SERVICE BULLETIN

Classification: EC00-024b	Reference: NTB00-070b	Date: June 7, 2004
------------------------------	--------------------------	-----------------------

2000-2001 MAXIMA MIL "ON" WITH DTC P0420 STORED – THREE WAY CATALYST FUNCTION

IMPORTANT: THIS BULLETIN HAS BEEN REVISED.

Figure 7

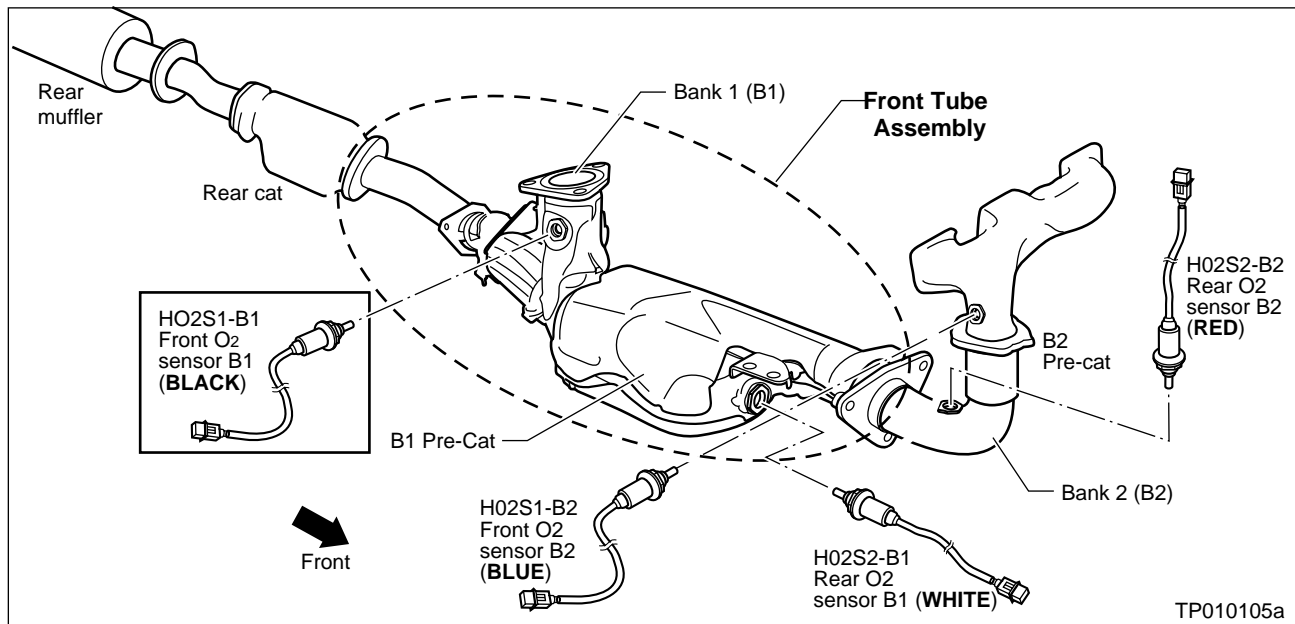
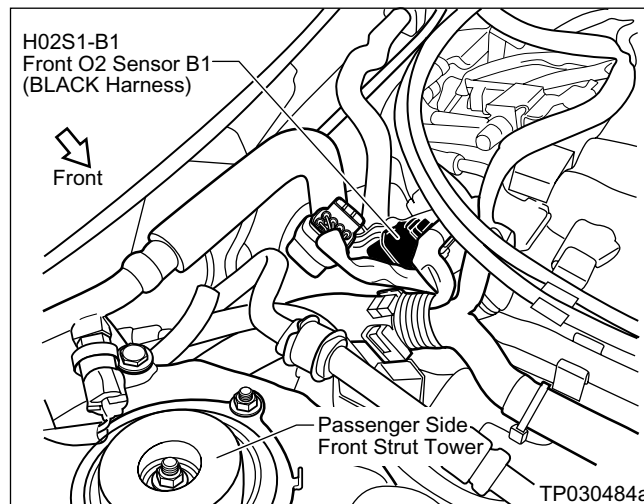
Replace the Front Tube Assembly and the Front H02S1-B1 Oxygen Sensor (see Figures 7 and 8 below).

- Refer to the **FE** section in the applicable ESM for the replacement procedures.
